FOUNDATION INVESTIGATION REPORT BY:
E. M. PETO & ASSOCIATES, LIMITED -
Big Creek Bridge at Delhi, Hwy. #3,
W.P. 138-63, District #2, London.

The above report submitted by E. M. Peto & Associates,
has been reviewed.

Review of Preliminary Plan D 5440-P1 -
Big Creek Bridge - W.P. 138-63,
Hwy. #3, District #2.

DRAWING No. D5440-PI

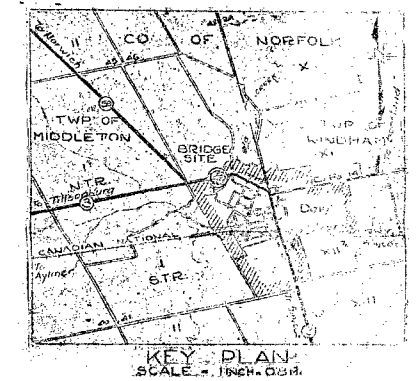
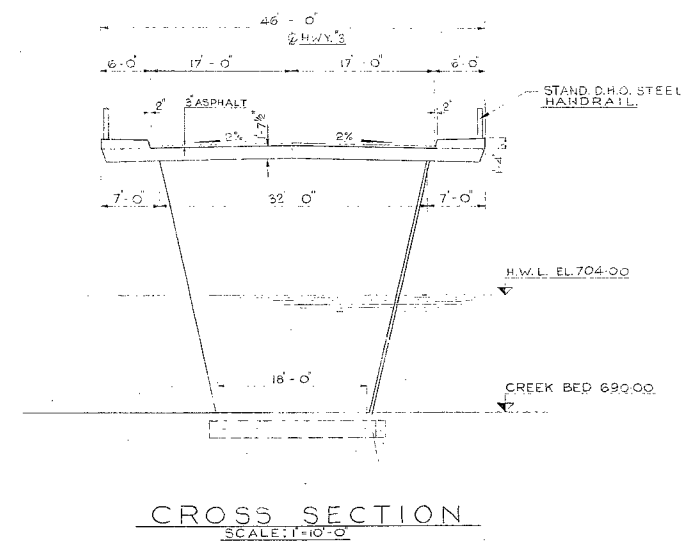
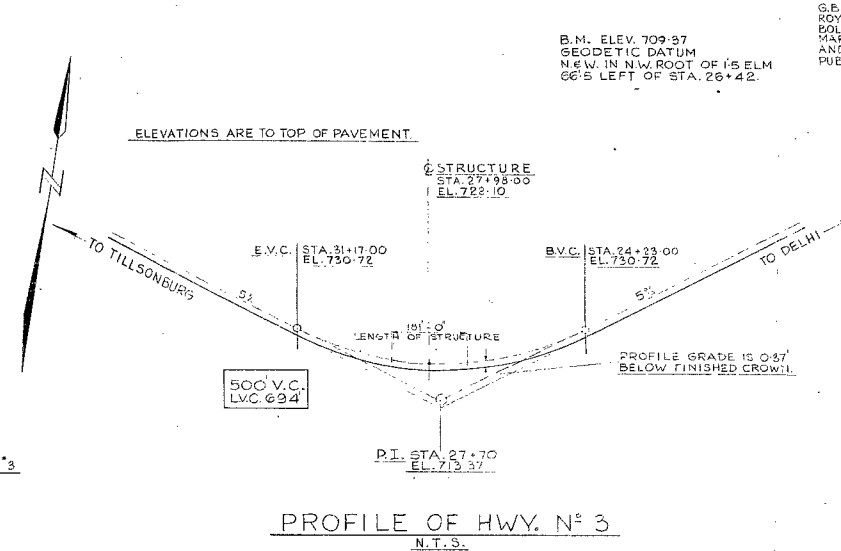
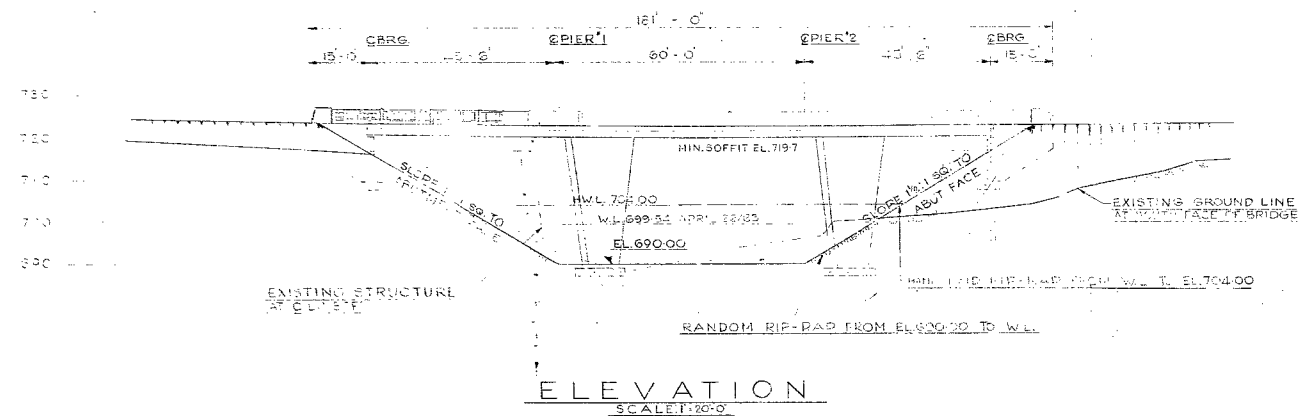
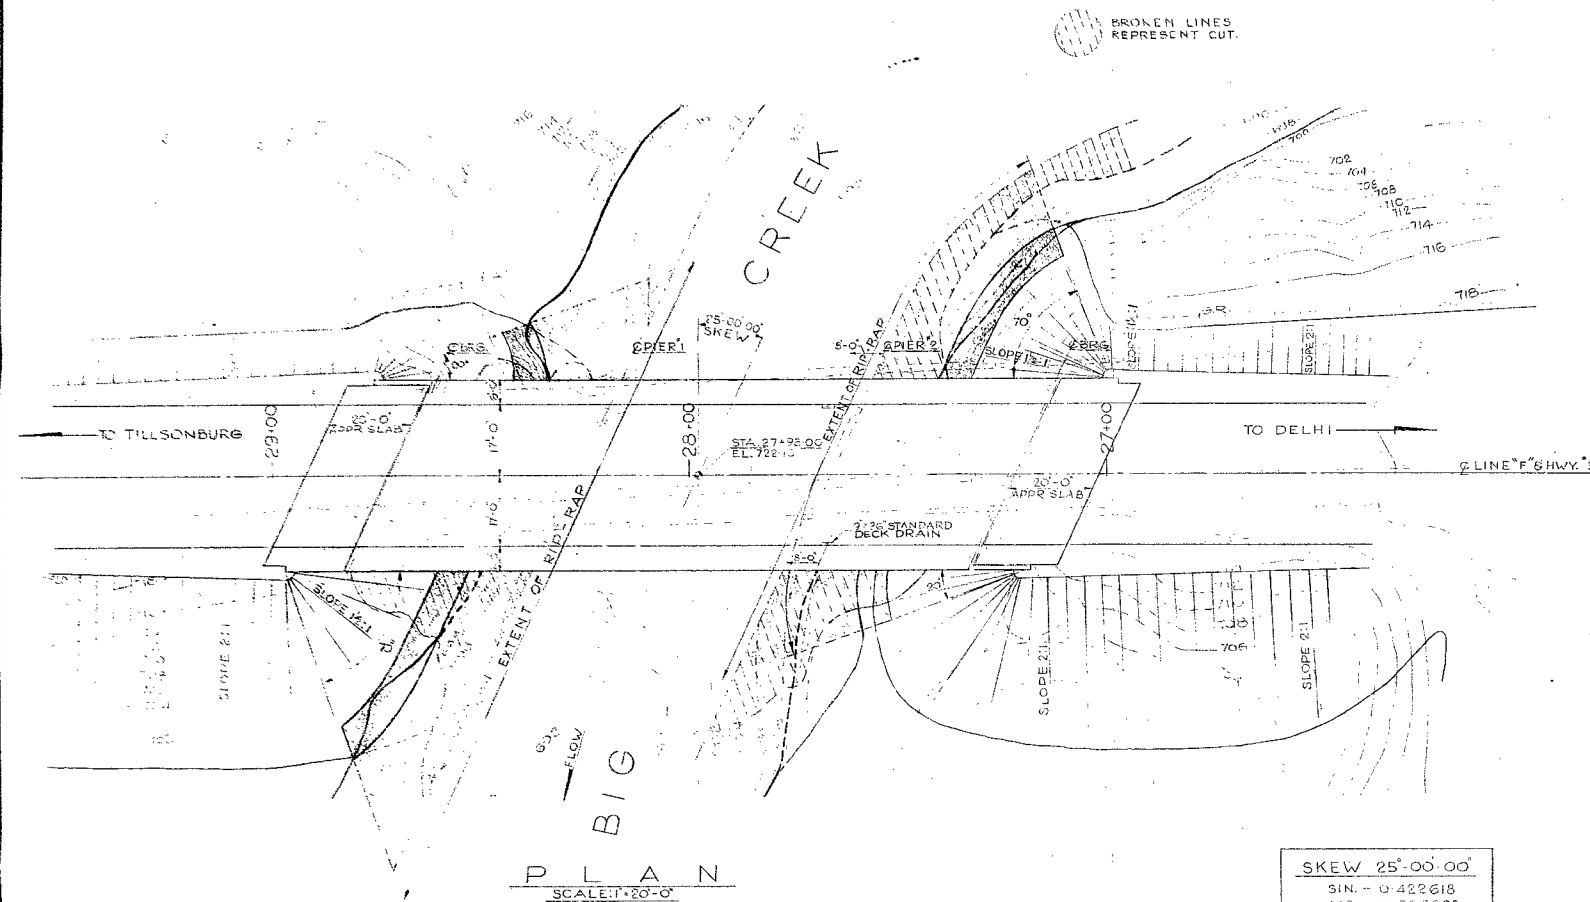
We have reviewed the above-mentioned Preliminary Plan and submit the following comments:

(4) It might be advisable to draw the Contractor's attention to the Soil Consultant's comments on the use of sheet piling for dewatering purposes.
